**WASHINGTON HISTORIC PRESERVATION COMMISSION**
Regular Scheduled Meeting - Agenda
Tuesday, January 7, 2019 6:00 PM

# 307 North Market Street

## Installation of an ATM Kiosk

# Staff Report

1/C2 SITE DETAILS

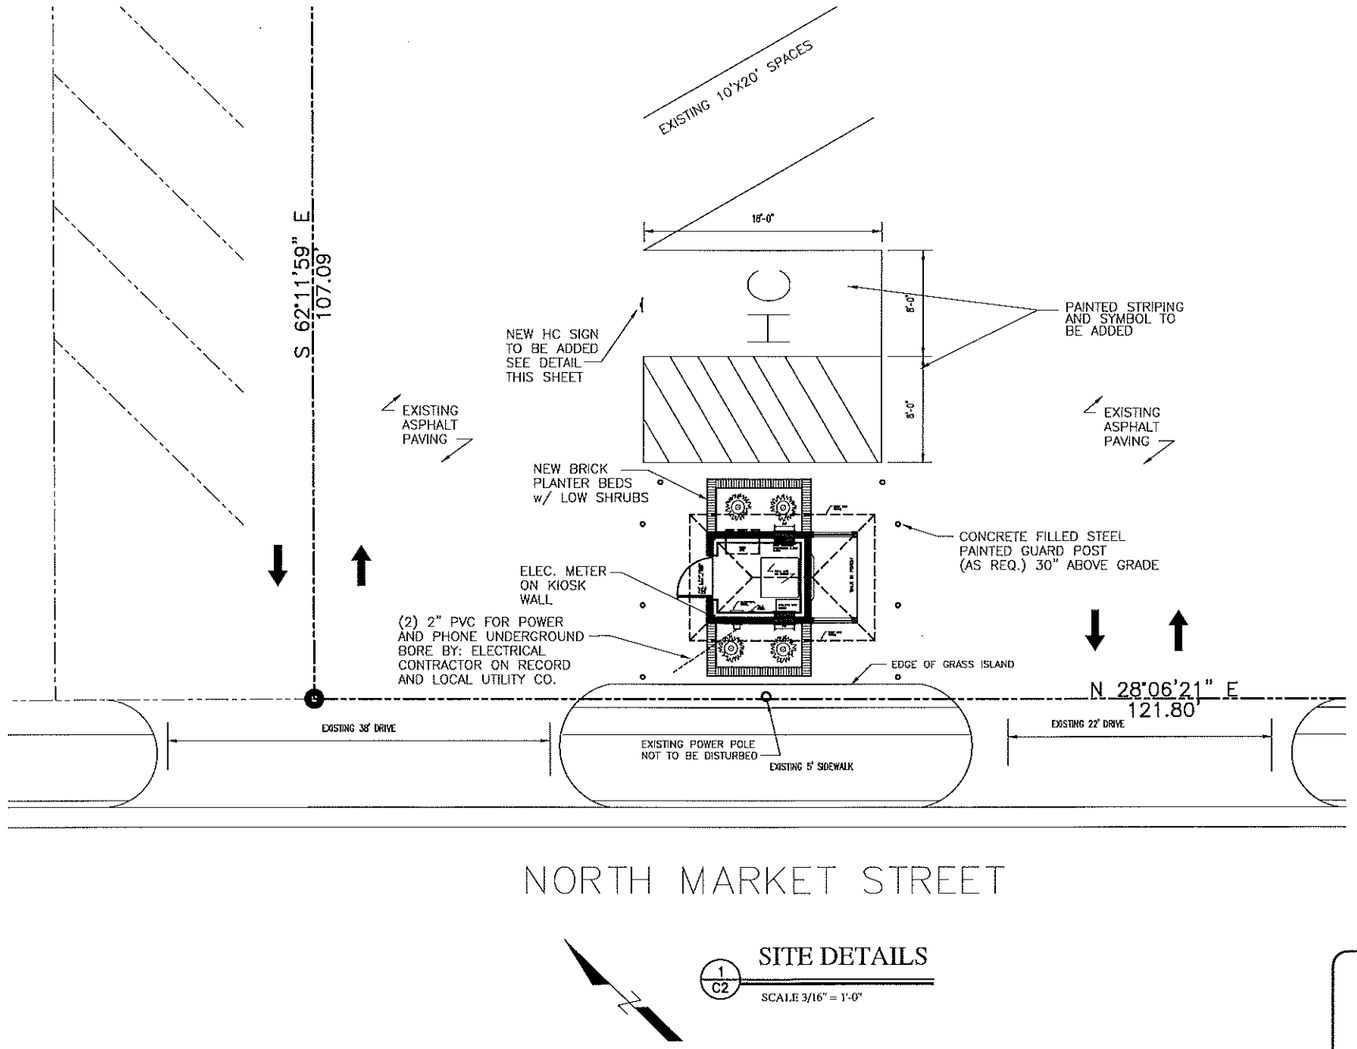
The proposed ATM kiosk is being constructed with the appropriate design, materials, and location. The proposal includes landscaping to that will help the modern machine blend with the historic district. Based on findings of fact, the request is congruous with the Historic Preservation Design Guidelines.

REVISION
1) 12/10/19 Per City Of Washington Historical review.
